SAN FRANCISCO BAY AREA RAPID TRANSIT DISTRICT

Re: BART Warm Springs Extension Project
General Order 95 Fencing Variance Request

WMJ-WAY, RETAINING WALL, AND FENCING PLAN
51 2462+50 TO 51 2483+50

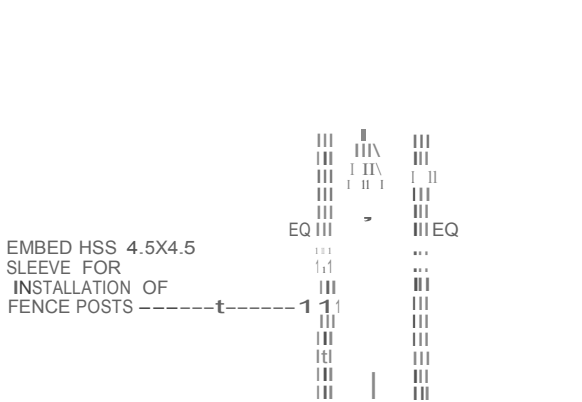
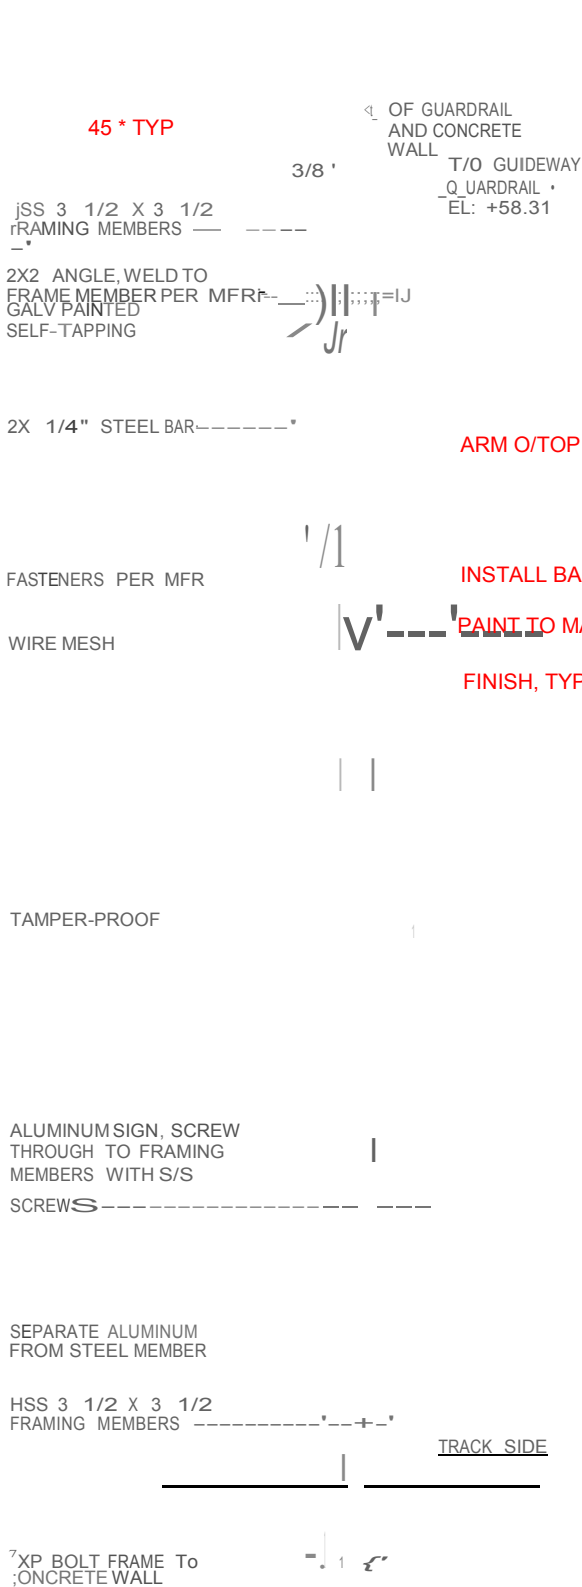
BART intends to install a 7-foot architectural fence mounted on a stem wall for a total height of 8.5 to 11 feet from finished grade at the public side of the wall to the top of fence. For the portion of the fence beyond the limits of the station platform and supervisor's building, the architectural fence will be further secured by a 12-inch inclined extension with three strands of barbed wire. The extension will be inclined 45° away from the fenced facilities. The portion of the fence along the station platform/supervisor's building will have an anti-climb flashing at the base of the architectural fence which reduces the possibility of a foothold on the stem wall supporting the fence and thus achieving an effective height of 10 to 11 feet above finish grade.

- Drawings X061 and X062 show the general plan of the WSX Project.
- Sketch of the overall layout of the Warm Springs/South Fremont Station site.
- Drawings C192 and C193 show the location and limits of the alternative fencing.
- Drawings A631-A and A631-B show a typical elevations and cross sections of the alternative fencing.

GUIDEWAY GUARDRAIL
SCALE: 3/4"=1'-0"

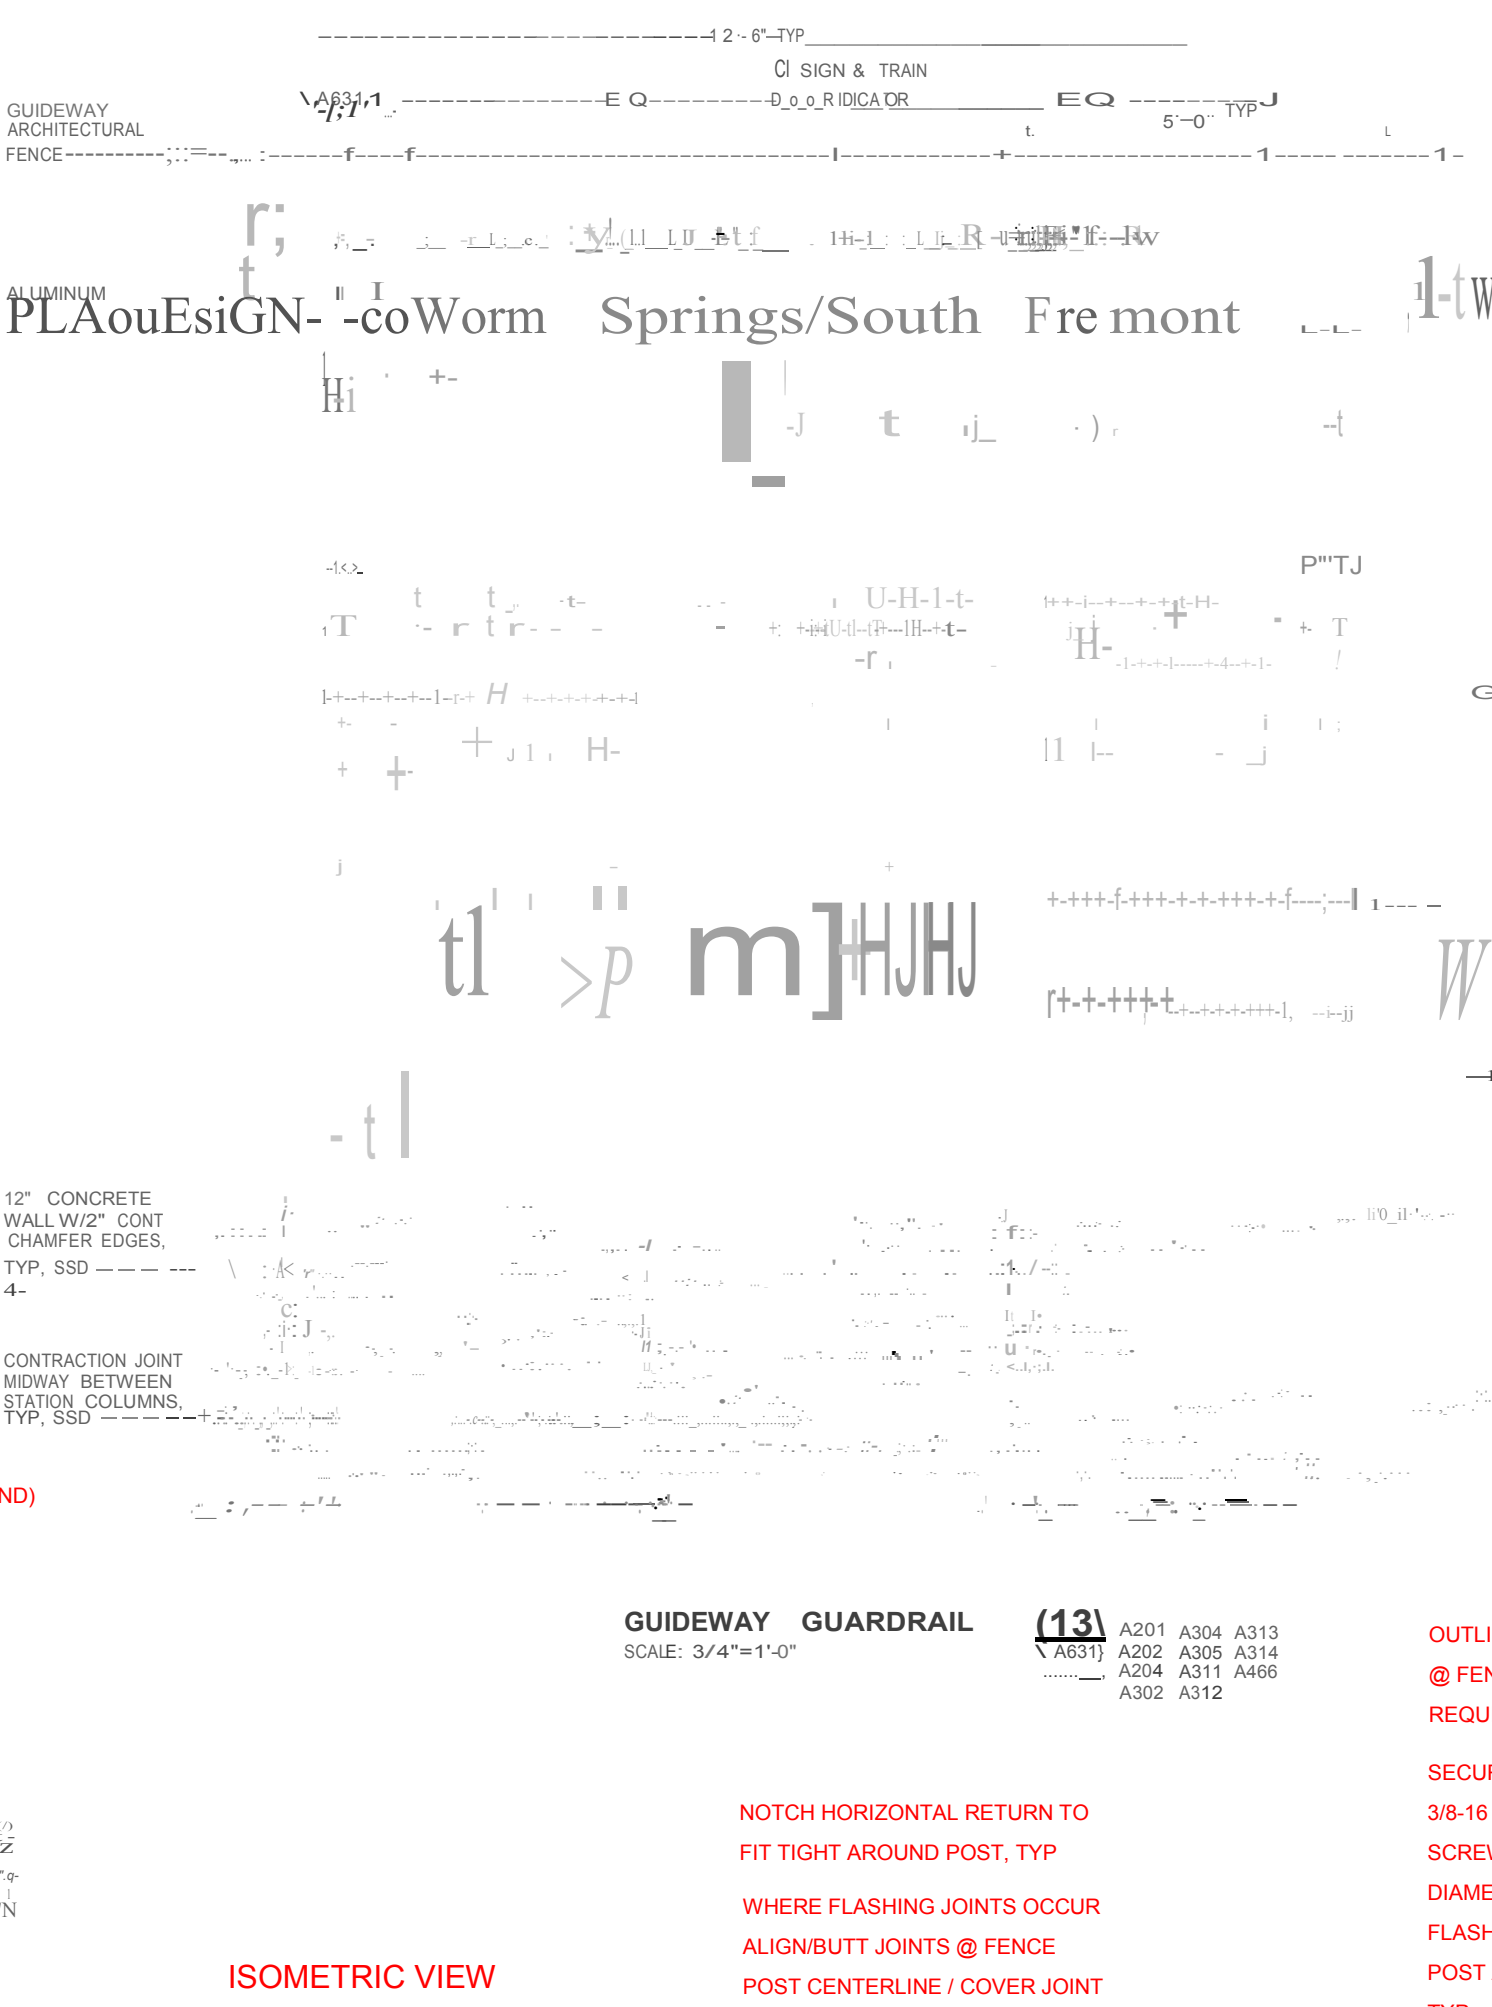
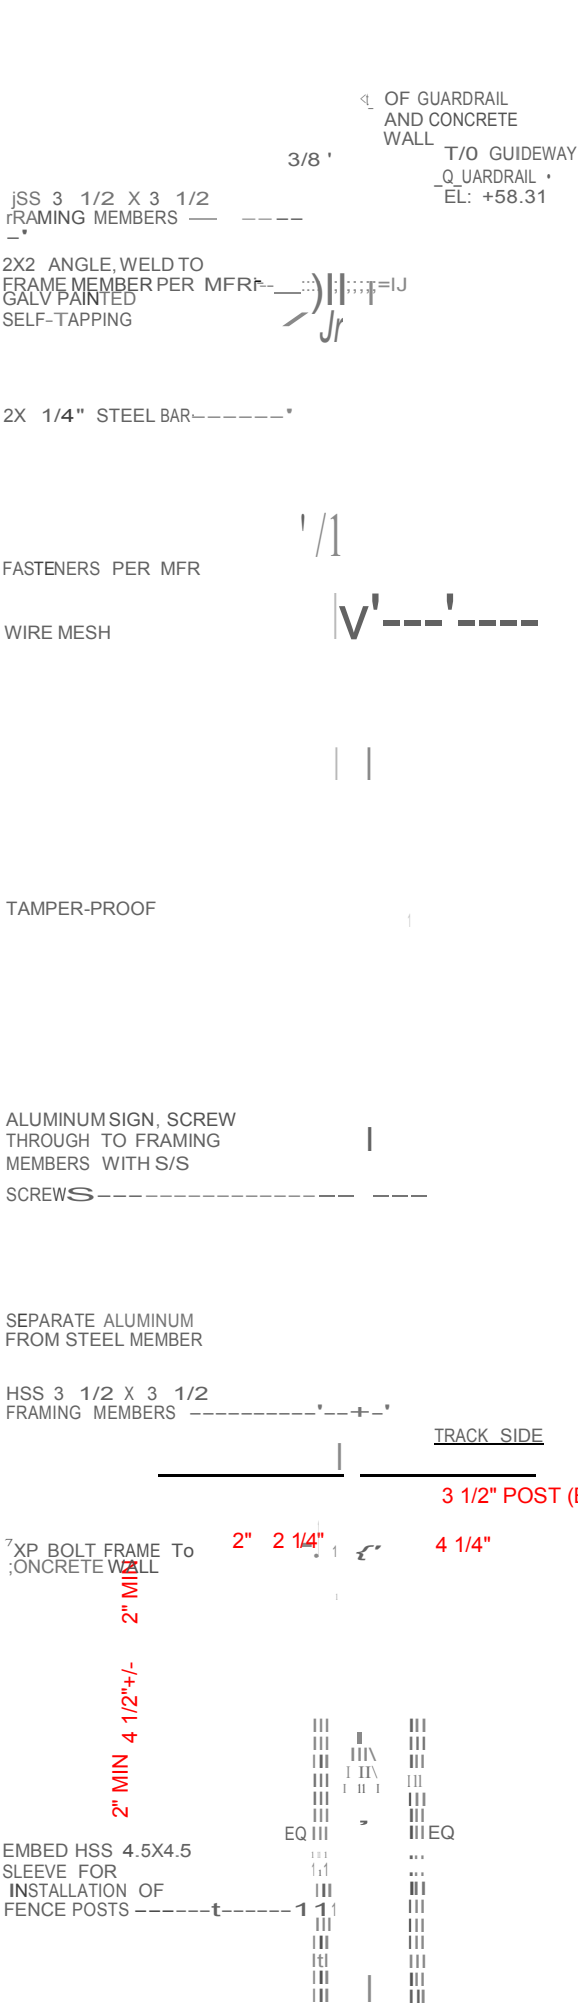
- Framing: 16-gage steel, mitered corners, welded, galvanized, painted;
- Wire Mesh: panelized woven steel mesh (10-gage wire), lockcrimp, with square pattern and 1-1/2" openings, galvanized and painted.;
- Barbed wire: 3 strands of PVC coated barbed wire in grey;
- Extension arms: 12" galvanized metal, inclined at 45° and painted to match fence frame;
- Stem wall: reinforced concrete, 12" thick with 2" chamfers and a 12-gage galvanized sheet metal flashing mounted to the top on the public side to prevent the wall ledge from being used as a foothold.
